Subject: **MHI's Response to US-APWR DCD RAI No. 887-6261 Revision 3 (SRP 09.01.04)**

Response to Request for Additional Information No. 887-6261
Revision 3

US-APWR Design Certification

QUESTION NO.: 09.01.04- 23

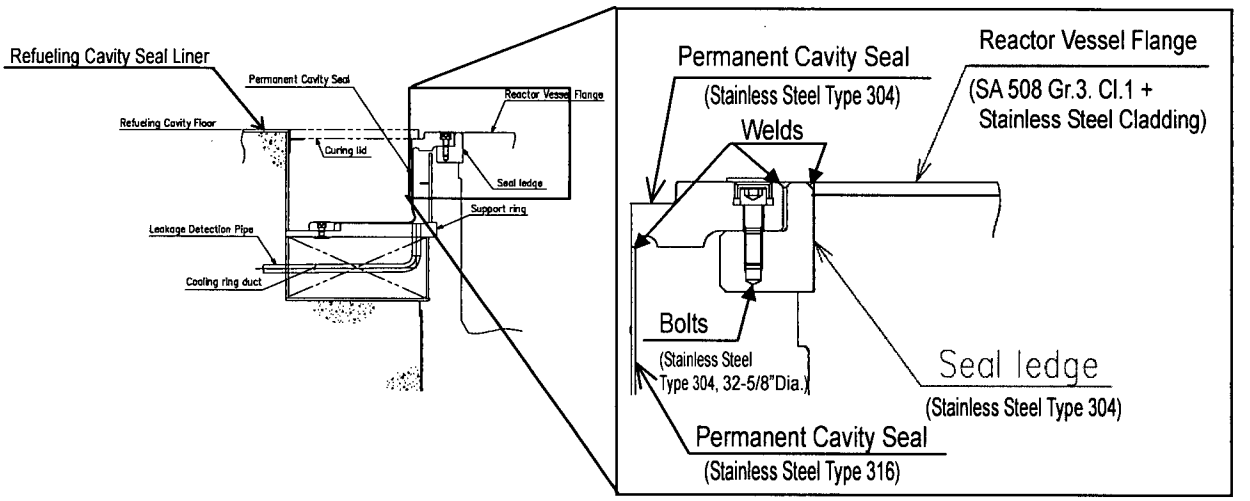
Based on the above elements, especially from the text and the figure that will be added to DCD Section 9.1.4.2.1, the staff deduced that some parts of the PCS are welded/bolted to the reactor vessel. However, the staff was not able to identify precisely which parts and how they are attached to the reactor vessel. Therefore, it is not clear to the staff whether the PCS design and installation could adversely affect the reactor vessel material and its integrity. The staff also noted that in revised Table 3.2-2 the applicant kept the identification number for "Codes and standards" as "5" corresponding to "codes and standards as in defined bases" and did not modify this number to "3" corresponding to "ASME Code, Section III, Class 3." The staff considers that this is not consistent with the new categorization of the PCS as a Class 3component, according to which the relevant ASME Code criteria should be selected.

Because of the importance of the interfaces between the PCS and the reactor vessel, the staff requests the applicant provide the following information to assure that the fabrication and installation of this PCS will not adversely impact the reactor vessel material or structural

integrity (e.g., to behave in a brittle manner or increase the probability of rapidly propagating failure):

- Describe in detail the PCS, especially the seal ledge, including the identification of the materials that are used;
- Identify any fasteners, bolts or welds used in the PCS;
- Describe in detail the connections between the PCS and the reactor vessel, particularly with the reactor vessel pressure retaining portion. If welding is used, describe any design considerations (such as weld joint type or location) or controls on welding (such as weld size or heat input limitations) that assure that welding has no adverse impact on the reactor vessel material or integrity.
- Justify why the identification number for "Codes and standards" in revised Table 3.2-2 does not correspond to the identification number for a Class 3 equipment implying that ASME Code Section III, Class 3 will not be applied to the PCS.

(First and Second Bullets)
The detail configuration and materials of the Permanent Cavity Seal (PCS) around the Seal Ledge (SL) are described below. The SL is ring type configuration attached to outside of the Reactor Vessel (RV) and made out of stainless steel. The SL is supported by the RV at the bottom, welded to the PCS and the RV flange at the top, and bolted to the PCS. The welding at the top of the SL are continuous welds and used for sealing the cavity water.

(Third Bullet)
There are partial penetration continuous welds and bolts connecting the PCS, the SL, and the RV. The first connecting weld (between the SL and the RV) and the second connecting weld (between the PCS and the SL) are both used for sealing but not for structural support. The SL is supported by the RV at the bottom, and is designed so that the weld is within the cladding of the RV, which does not affect the structural integrity of the RV. The PCS is bolted and seal welded to the SL since it can only be installed at site. The welding between the SL and the RV will be controlled and inspected based on ASME because of the first connecting weld to pressure retaining portion.

(Fourth Bullet)
Since the PCS is not a pressure-retaining component for the Reactor Coolant System (RCS), ASME BPVC Section III does not apply to the seal itself. In terms of the relationship with the reactor vessel, to which ASME BPVC Section III, Subsection NB applies, the ASME BPVC Section III is not applicable to the PCS and the connecting weld between the seal and the SL for the following reasons:

- The PCS is indirectly attached to the reactor vessel through the SL, as shown in the figure above.
- The SL has neither pressure-retaining function nor structural function.
- In accordance with ASME BPVC Section III, NB-1132.2 (e), stating that "The first connecting weld of a welded nonstructural attachment to a component shall be considered part of the attachment. At or within 2t from the pressure-retaining portion of the component, the first connecting weld shall conform to NB-4430.", the SL and its connecting weld to the RV is not a part of the vessel, but an attachment to the vessel.
- Moreover, while the first connecting weld (in this case, the connecting weld between the SL and the vessel) is required to conform to NB-4430, there is no requirement for the second connecting weld, namely, the connecting weld between the SL and the PCS.
